## Corrections of Hardware Manual

# MB90385 -

### Addendum, MB90385 Hardware Manual (CM44-10118-1E)

This is the Addendum for the Hardware Manual CM44-10118-1E of the MB90385 microcontroller series. It describes all known discrepancies of the MB90385 microcontroller series Hardware Manual.

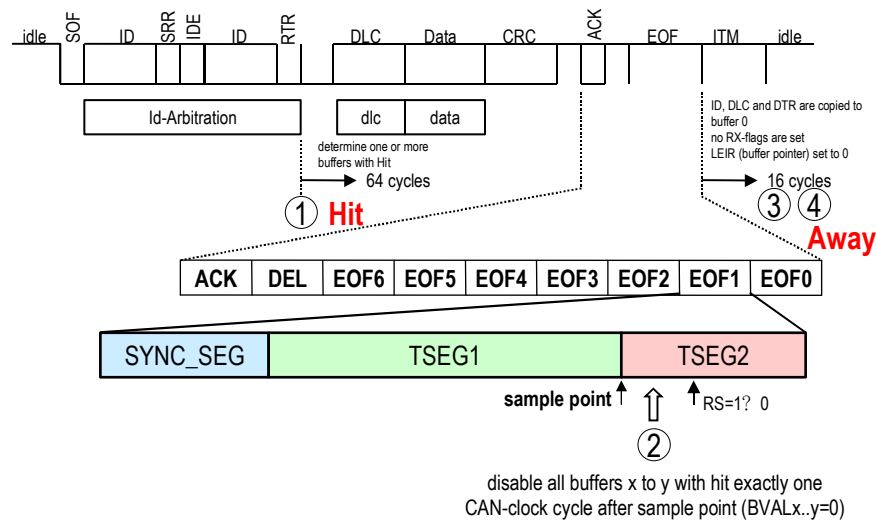
When disabling message buffers by the BVAL register, it must be avoided that the write operation to the BVAL register coincides with the store operation of the received message in the CAN Controller.

The following diagram illustrates the timing to be avoided for the BVAL write operation.

- ① CAN-controller determines buffers, which can store the message, because their acceptance filters had been passed.
- ② Software disable all buffers with hit exactly one CAN-clock cycle after the sample point of EOF1.
- ③ CAN-controller stores received ID, DLC and data in buffer 0 regardless of the buffers determined in ①.
- ④ CAN-Controller sets LEIR to point to buffer 0 but RX-flags (RCR, ROVR, RRTRR) are not set.

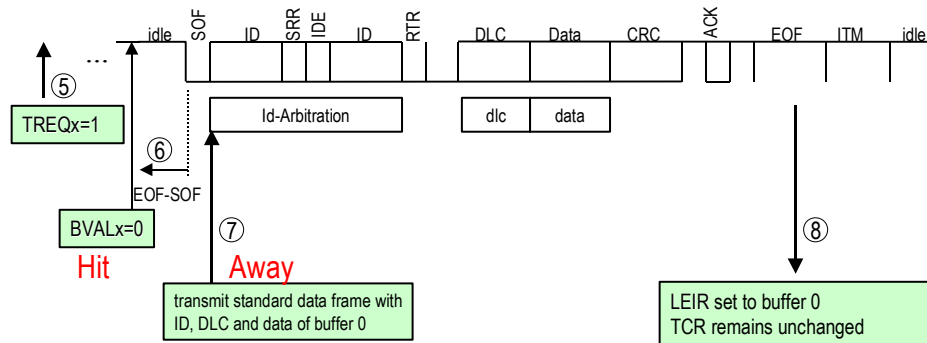
When there is a pending transmission of buffer x and the CAN bus status is in Intermission or in Bus Idle, the CAN-controller will load the message from buffer x in order to send it. If this load operation coincides with disabling the pending message buffer x by clearing the BVAL bit, this results in transmission of a Standard message. This message consists of RTR=0, IDE=0, DLC, 11 ID bits and Data stored in the message buffer 0. Note that this coincidence has to happen within a specific CAN-clock cycle. Hence, the probability is very low. The position of that cycle depends also on previous frame reception and occurrence of error frames.

When disabling message buffers by the BVAL register, it must be avoided that the write operation to the BVAL register coincides with the preparation for the next transmission in the CAN Controller. The following diagram illustrates the timing to be avoided for the BVAL write operation.

- ⑤ Software requests transmission of buffer x by setting TREQx.
- ⑥ Software disables the buffer x by clearing BVALx.
- ⑦ CAN-controller transmits a standard data frame with ID, length code and data of buffer 0.
- ⑧ After completion of frame only LEIR is updated for buffer 0. However, TCR is not set (neither for buffer 0 nor for buffer x).

Chapter 3.1.2 Memory Map

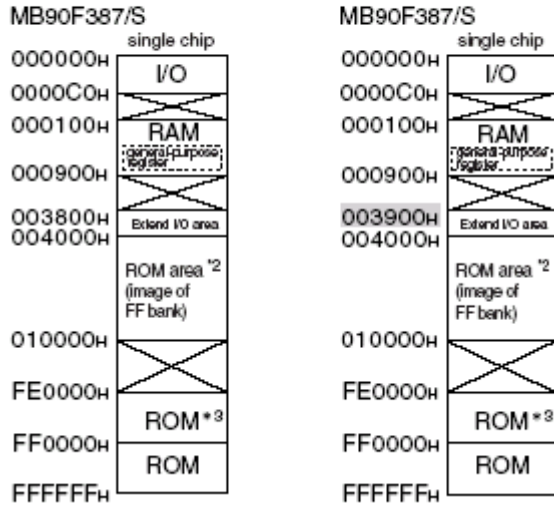
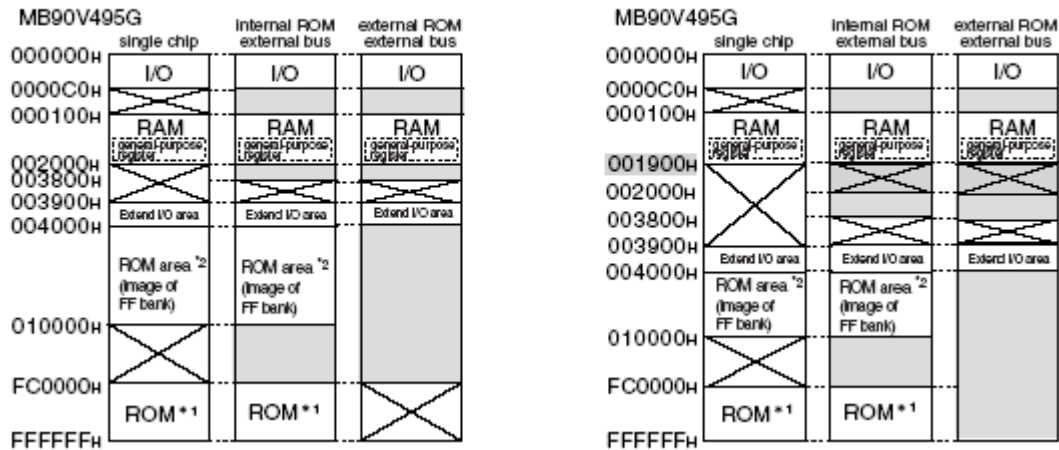
Figure 3.1-3 was corrected as indicated by shading below.

Figure 3.6-1 Oscillation Stabilization Wait Interval for the MB90385 Series during a Power-on Reset

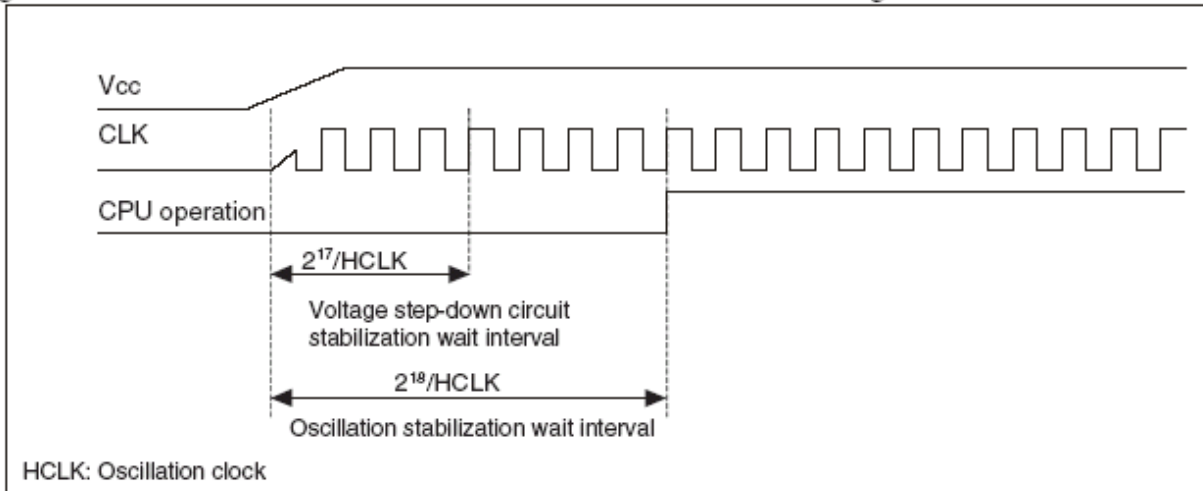
Figure 3.6-1 was moved next Table 3.6-2.

Chapter 9.2 Block Diagram of Watch Timer

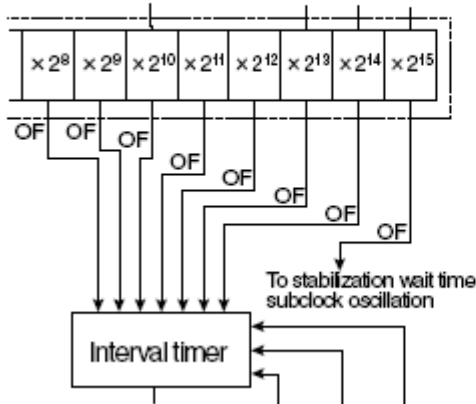
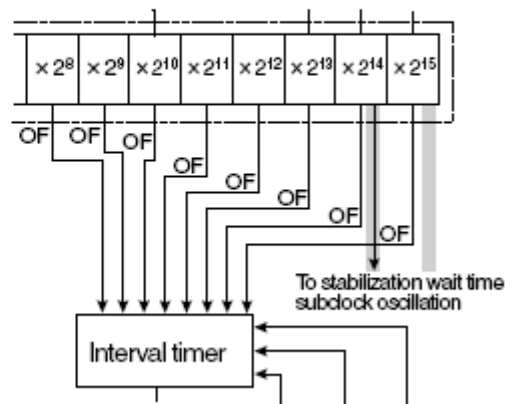
"Figure 9.2-1 Block Diagram of Watch Timer" was corrected as indicated by the shading below:

Figure 12.5-1 Clearing Interrupt Request Flag Bit (EIRR:ER) when Level Set

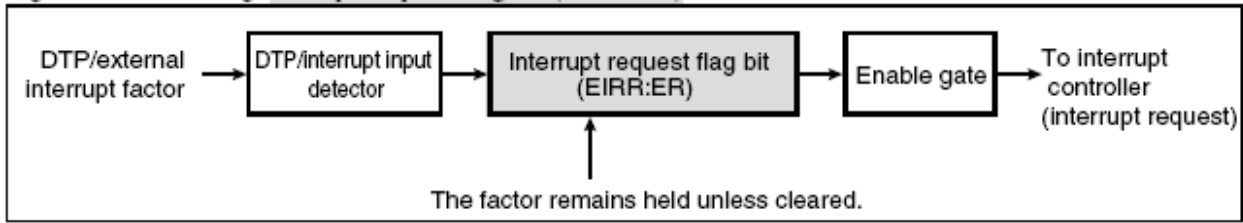
- When a level causing an interrupt factor is input with level detection set in the detection level setting register, the interrupt request flag bit (EIRR:ER) of the DTP/external interrupt factor register is set to 1 and the factor is held as shown in Figure 12.5-1 "Clearing Interrupt Request Flag Bit (EIRR:ER) when Level Set".

With the factor held in the interrupt request flag bit (EIRR:ER), the request to the interrupt controller remains active if the interrupt request is enabled (ENIR: EN = 1) even after the DTP/external interrupt factor is cancelled. To cancel the request to the interrupt controller, clear the interrupt request

Figure 12.5-2 DTP/External Interrupt Factor and Interrupt Request Generated when Interrupt Request Enabled

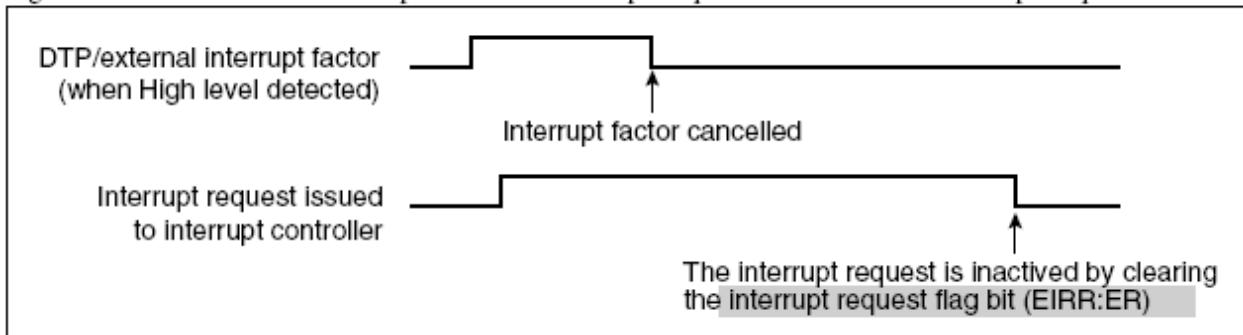
flag bit (EIRR:ER) as shown in Figure 12.5-2 "DTP/External Interrupt Factor and Interrupt Request Generated when Interrupt Request Enabled".
